HORSHAM DISTRICT COUNCIL CONSULTATION

TO:	Horsham District Council – Planning Dept
LOCATION:	Blakers Yard Worthing Road Dial Post Horsham
DESCRIPTION:	Application for Approval of Details Reserved by Condition 7 to approved application DC/20/2358
REFERENCE:	DISC/26/0048
RECOMMENDATION:	More Information / Modification
SUMMARY OF COMMENTS & RECOMMENDATION:	
More information/modification is requested in order to recommend the discharge of Condition 7. Please see details below.	
MAIN COMMENTS:	
<u>Condition 7</u> <i>Notwithstanding the details submitted as part of the application and superseded by way of revised details, no part of the development hereby permitted within Site B shall be first occupied until full details of all hard and soft landscaping works have been submitted to and approved, in writing, by the Local Planning Authority. The details shall include plans and measures addressing the following:</i>

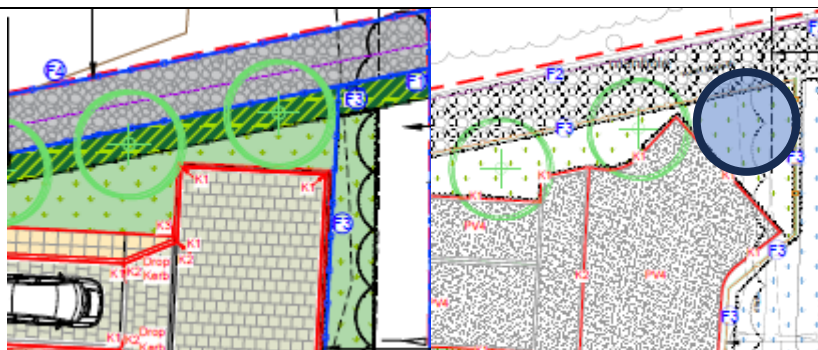
a) <i>Details of all existing trees and planting to be retained</i> 1. No concerns. b) <i>Details of all proposed trees and planting, including schedules specifying species, planting size, densities and plant numbers and tree pit details</i> 2. We note various instances where trees are proposed within or in proximity to easement zones for drainage and utilities. We therefore request the inclusion of tree root barriers to mitigate the risk of root intrusion and ensure the long-term integrity of both the drainage infrastructure and the planting scheme. Specification of root barriers must be provided and locations of all proposed root barriers must be indicated on the landscape plan. 3. We also note that the road layout has been amended to include a turning point, creating a poor relationship with one of the proposed trees. To avoid risk of damage or loss, we request that this tree is moved further away from the hardscaping. We recommend the position in blue, below [DC/20/2358 left, current proposal right]:
